SYSTEM TRANSFER REVISION

LOUISIANA POWER & LIGHT COMPANY
WATERFORD S.E.S. UNIT NO. 3
1977-1985 MW INSTALLATION

FLOW DIAGRAM
SAFETY INJECTION SYSTEM
EBASCO SERVICES INCORPORATED

LOU-1564-G-167 SHEET 1 OF 2

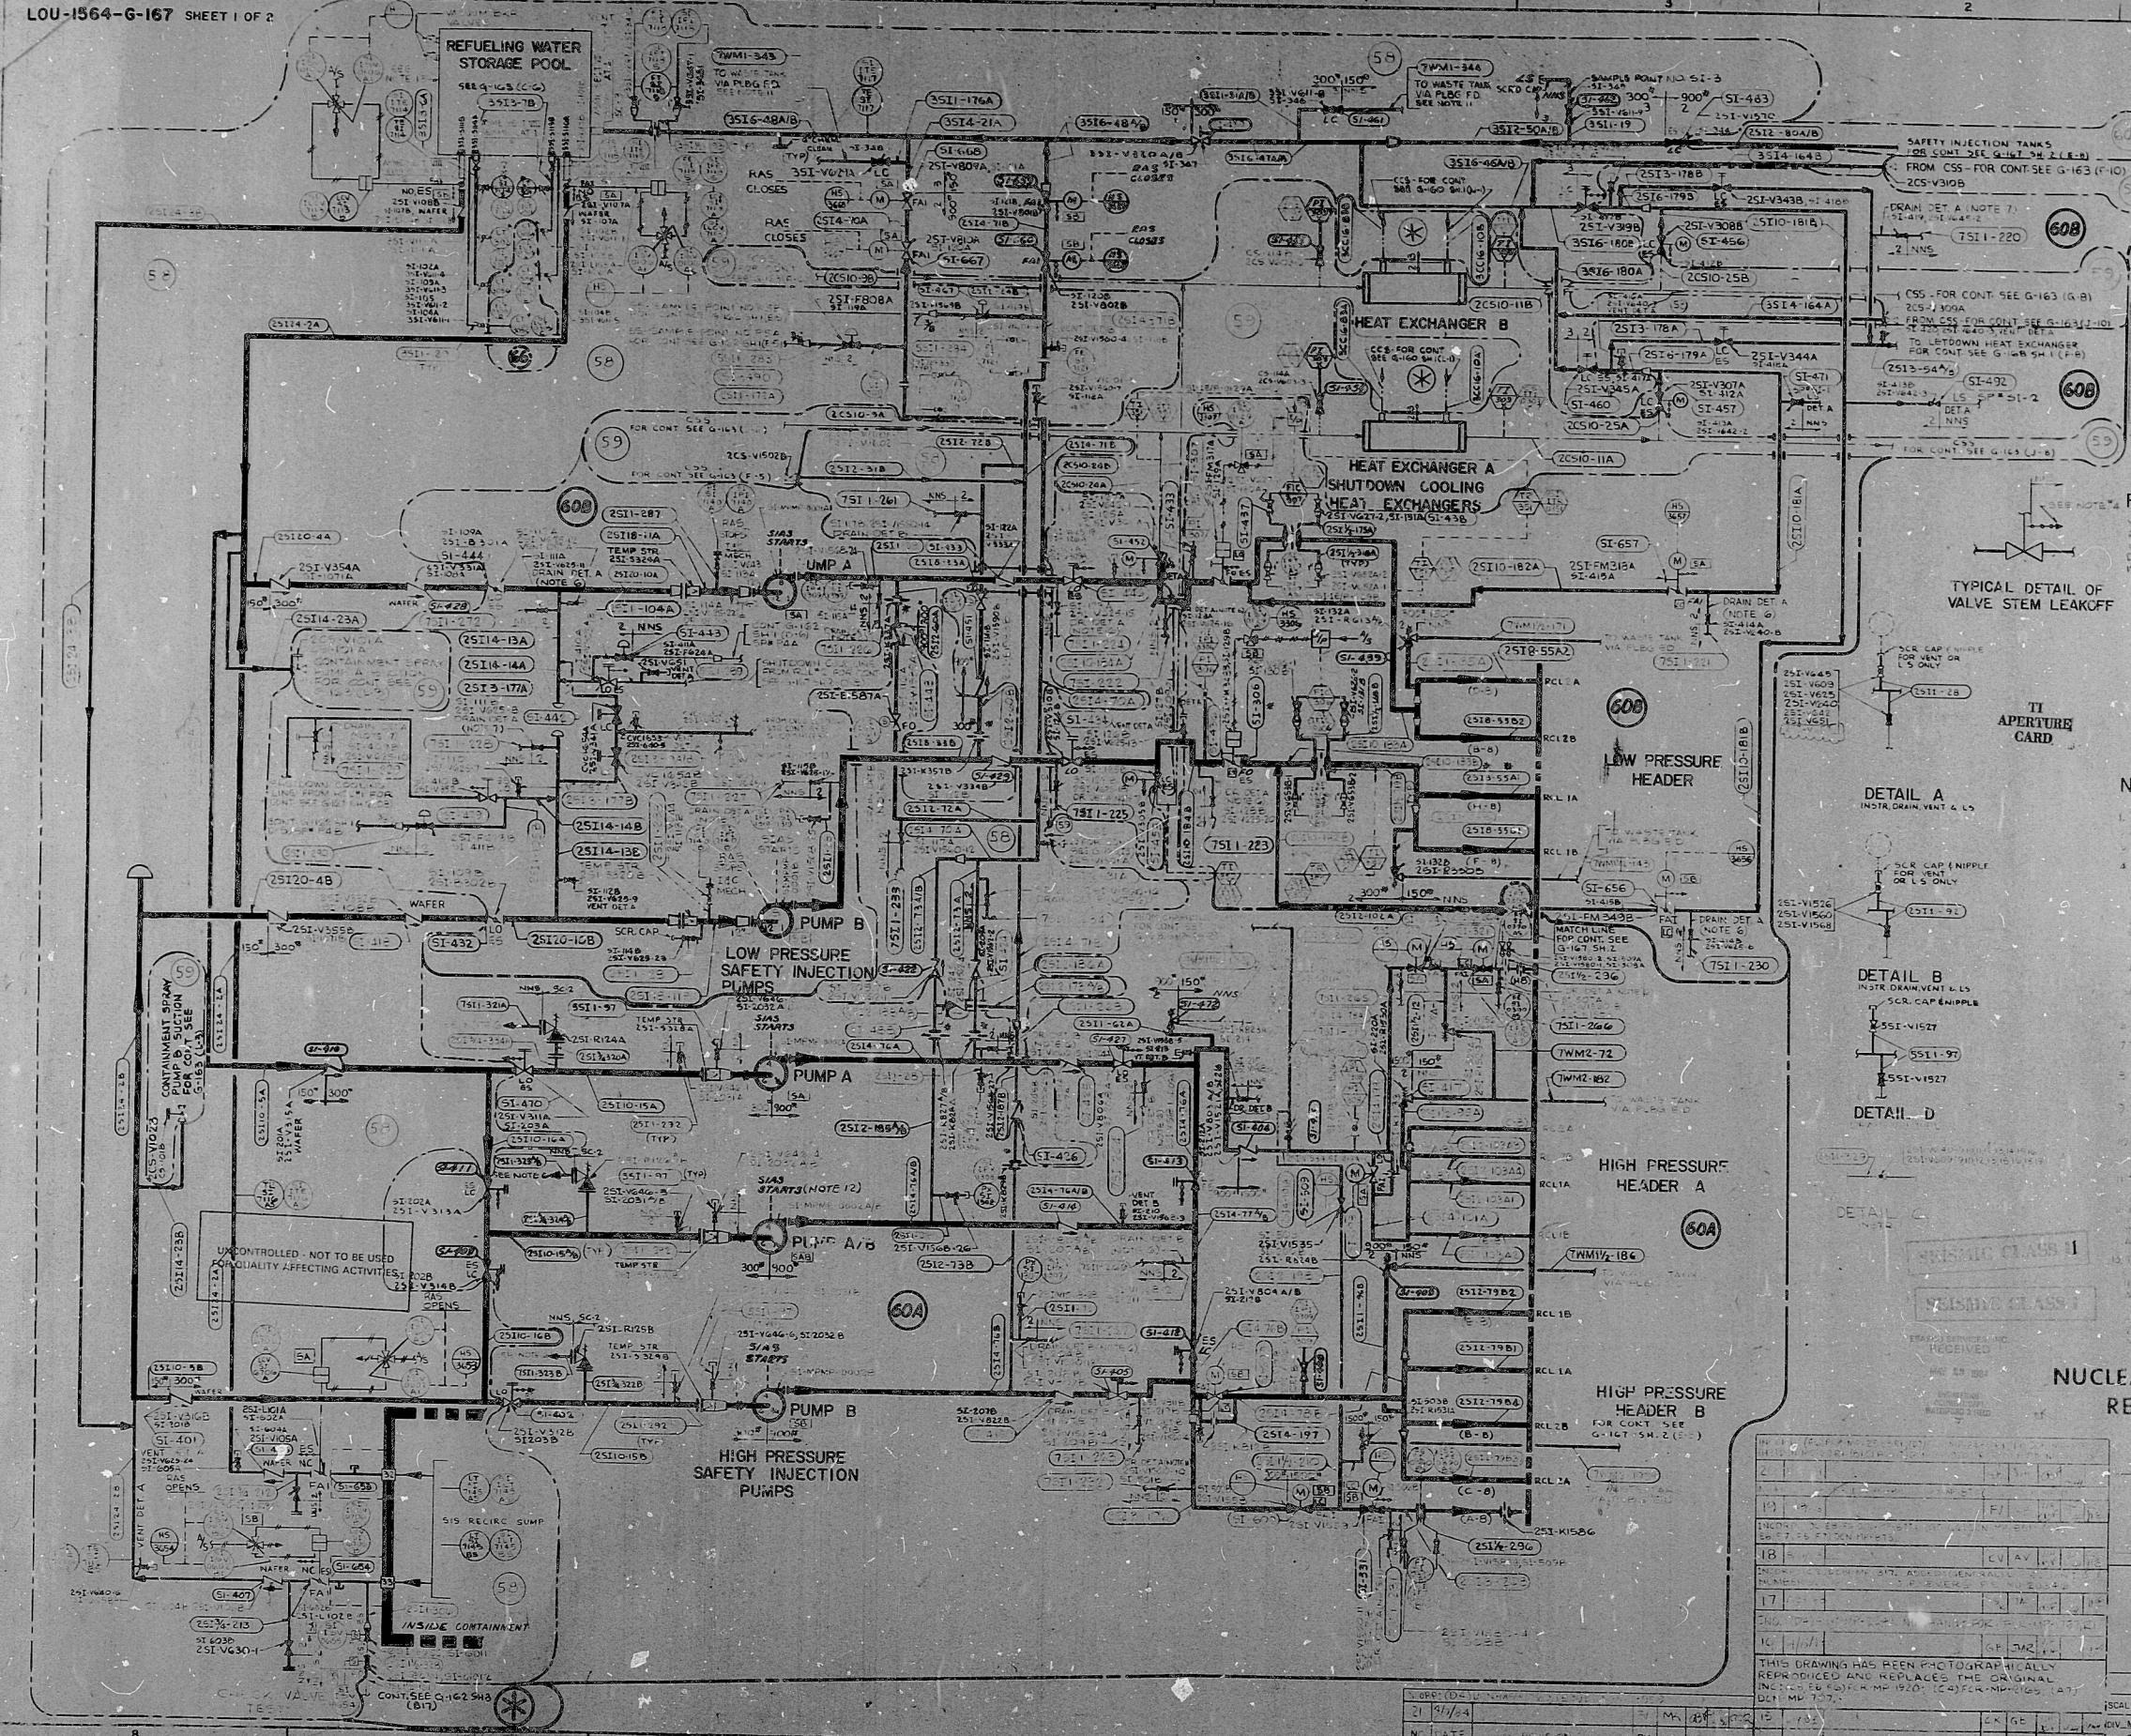
THIS DRAWING HAS BEEN MARKED UP TO SHOW THE BOUNDARIES FOR SYSTEMS TRANSFERRED TO LOCAL PLANT STAFF. NO WORK IS TO BE PERFORMED WITHIN THE INDICATED BOUNDARIES PRIOR TO LOCAL APPROVAL.

REVISION	BY	CHK	SYSTEM TRANSFERRED
ST 0	MM	JH	600 MW SYSTEM
ST 1	JH	JH	59 MW SYSTEM
ST 2	JH	JH	58 MW SYSTEM
ST 3	JH	JH	60A 60B SYSTEM
ST 4	RR	MM	66 MW SYSTEM
